NINE MILE POINT NUCLEAR STATION

SUBJECT: Nine Mile Point Nuclear Station
Unit No. 2, Docket No. 50-410

License Amendment Request Pursuant to 10 CFR 50.90: Extension of the
Completion Time for an Inoperable Diesel Generator – Technical Specification 3.8.1,
AC Sources – Operating

Figure 1: Simplified One Line Diagram – NMP2 Emergency 4.16 kV Distribution

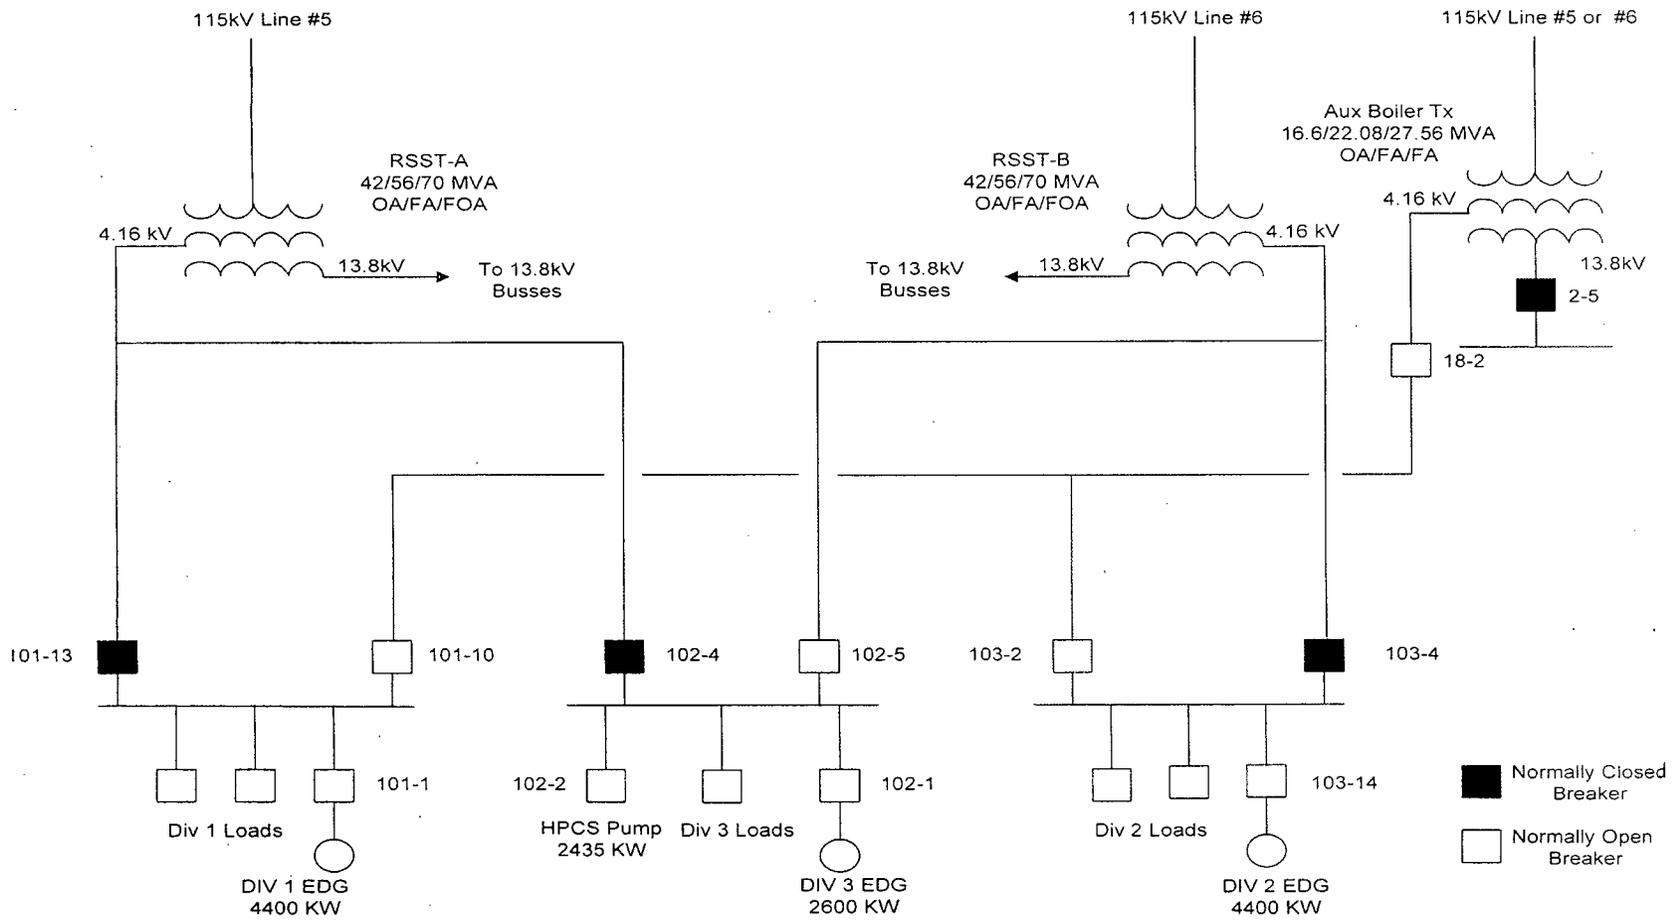
part of the permanent plant design and is illustrated in Figure 1 (a simplified one-line diagram of the NMP2 onsite 4.16 kV emergency electrical distribution system). The existing SBO special operating procedures describe the actions needed to establish the cross-connection and contain the necessary precautions, limitations, and details to minimize the potential for human errors and ensure that this feature will only be used for its intended purpose. This feature is credited in the PRA for the proposed DG CT extension.

The cross-connection is accomplished by stripping one of the de-energized buses (Division 1 or Division 2) of its loads, defeating the HPCS automatic initiation signals, and manually performing breaker line-ups to energize either the Division 1 or Division 2 emergency bus from the Division 3 DG. The HPCS pump will be disabled (placed in pull-to-lock). When the selected 4.16 kV emergency bus is energized, a service water (SW) pump will be started and SW flow will be aligned to the Division 3 DG. The SM will then determine the priority for energizing additional loads based on plant needs, while assuring that the Division 3 DG loading limits are not exceeded. These actions can be readily accomplished by on-shift personnel within two hours of initiation of the SBO condition.
